A465 Heads of the Valleys

Sections 5 + 6: *Dowlais Top - Hirwaun*

## A465 Heads of the Valleys Sections 5 and 6: Dowlais Top to Hirwaun

Environmental Statement Supplement Volume 1: Main Text  
March 2018

**Table 4.7a : Design development of Croesbychan junction since publication of Draft Orders in July 2017**

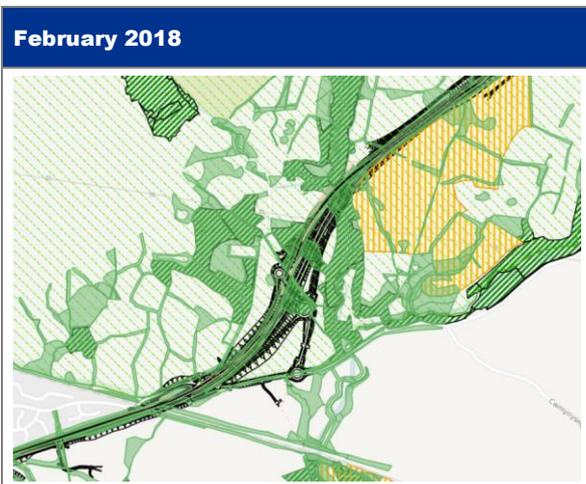
**An additional 'Table 4.7a: Design development of Croesbychan junction since Draft Orders' should be inserted:**
